**AGENDA**  
**Planning & Zoning Commission**  
**Tuesday, March 19, 2019**  
**6:30pm**

1.	Project:	Haymeadow Subdivision Filing 1
	File #:	S18-01
	Applicant:	Rick Pylman of Pylman & Associates and Brandon Cohen of Abrika Properties.
	Location:	660-acre property located east and south of the Eagle Pool and Ice Rink Parcel.
	Staff Contact:	Morgan Landers, Town Planner
	Request:	Request to formally plat the entire boundary of the Haymeadow property and will address the requirements of the approved Haymeadow Annexation and Development Agreement that are triggered at Final Plat approval.

**Planning and Zoning Commission  
Meeting Minutes  
March 5th, 2019**

SHEET 6 OF 10

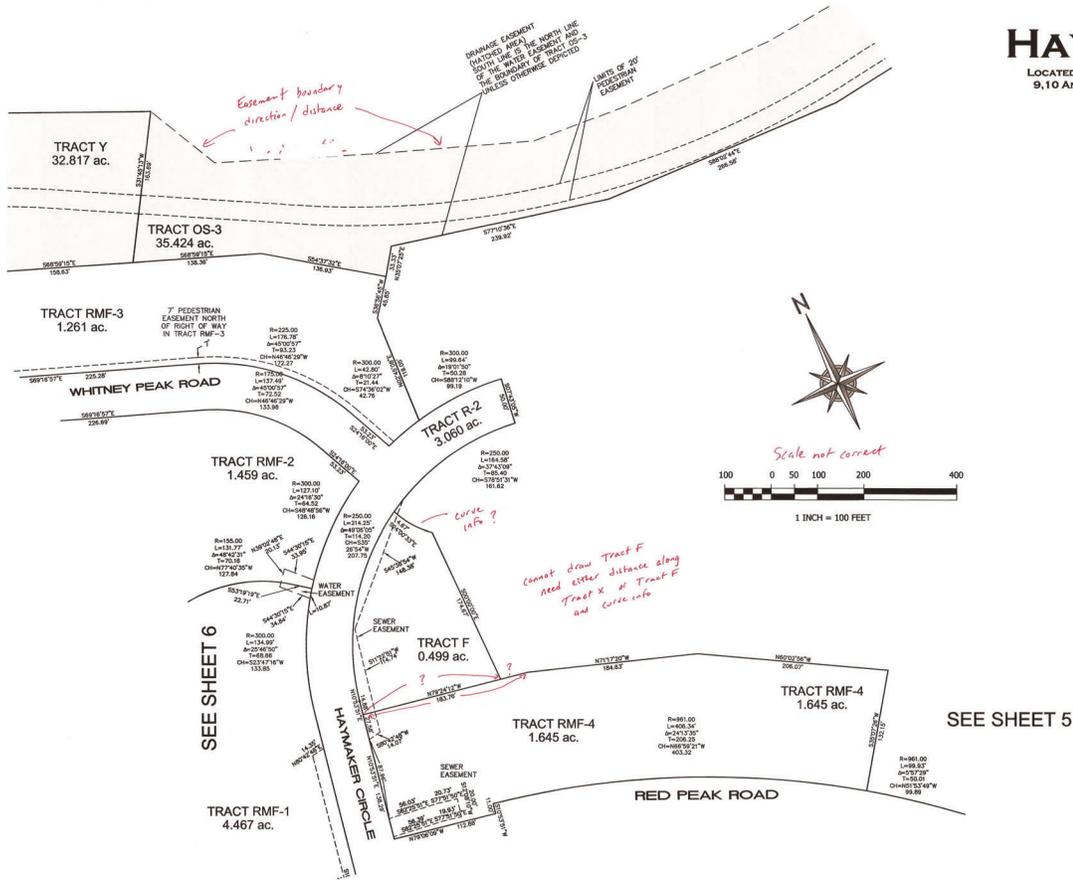
- f. Each lot should be designated an address indicated on this sheet in the plat.
7. Sheet 6 of 10
    - a. The Drainage Easement Note does not need to include the Water Easement language as the water line does not extend to this point of the subdivision.

1. There is no annotation for the curve between Tracts F and X.
2. It is unclear to what the annotation of  $S24^{\circ}00'33''E$  4.67' pertains.
3. For Tracts F and X, I cannot calculate the individual areas as there is a curve on the boundary between the Tracts which is not annotated and indeterminate as to location.
4. For Tract RMF-1, see Comment 6, Sheet 4.

5. See Comment 2, Sheet 4.
6. There should be a tie to the northerly terminus of the sewer easement on the easterly line of Haymaker Circle.
7. There should be a tie to the northerly terminus of the sewer easement on the westerly line of Haymaker Circle.
8. The annotation for the curve with a delta of  $45^{\circ}00'57''$  and radius of 175.00' overlays linework and is difficult to read.
9. The label "SEE SHEET 6" should be "SEE SHEET 4".
